# What are the significant changes between the 2018 and 2021 International Residential Code (IRC)?

This document includes a summary of significant changes to the 2021 International Residential Code (IRC) and includes the PA Uniform Construction Code Review and Advisory Council (RAC) Report Amendments. This document also provides further information for the identified code changes

**FIGURE R311.7.4**  
**WINDER TREAD AND LANDING DETAIL**

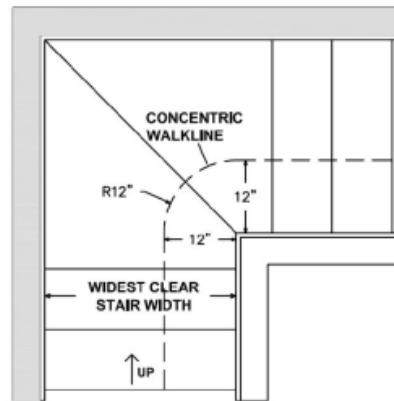
- **R311.7.4** - PA UCC RAC modifications to revise walkline requirements to the language under the previously adopted modification under the 2018 adoption.

**R311.7.4 Walkline.** *The walkline across winder treads and landings shall be concentric to the turn and parallel to the direction of travel entering and exiting the turn. The walkline shall be located 12 inches (305 mm) from the inside of the turn. The 12-inch (305 mm) dimension shall be measured from the widest point of the clear stair width at the walking surface. Where winders are adjacent within a flight, the point of the widest clear stair width of the adjacent winders shall be used.*
